SUBJECT: REQUEST FOR ADDITIONAL INFORMATION FOR REVIEW OF THE MODEL
NO. NPI-20WC-6 MkII PACKAGE

Docket No. 71-9215
EPID NO. L-2017-LLA-0120

Request for Additional Information
Docket No. 71-9215
Model No. NPI-20WC-6 MkII

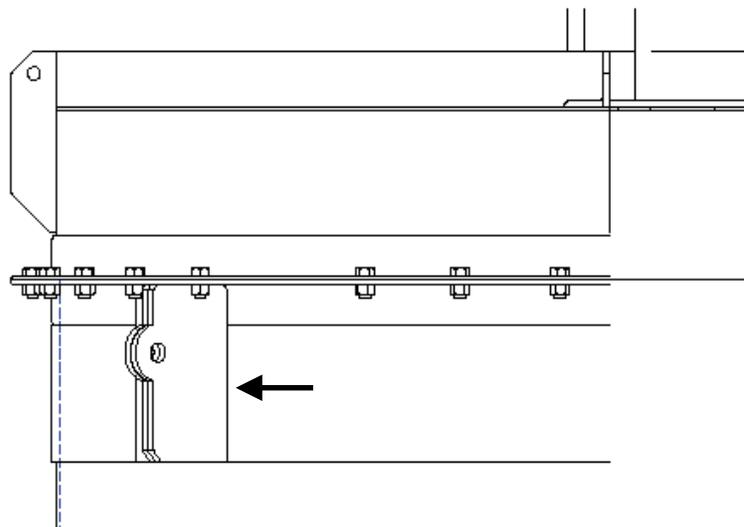
1. Identify the item, shown in the Figure below, at which the arrow is pointing.

The figure above was taken from view A-A in drawing 240116, Rev. H. Based upon its location relative to other package components shown in other views of the drawing, the item in the figure at which the arrow is pointing appears to be the tie down bracket. However, the addition of the tie down bracket to this view of the package was not identified in the changes made to the drawing and the item does not appear in previous revisions of drawing 240116. The drawing should be modified to identify this item.
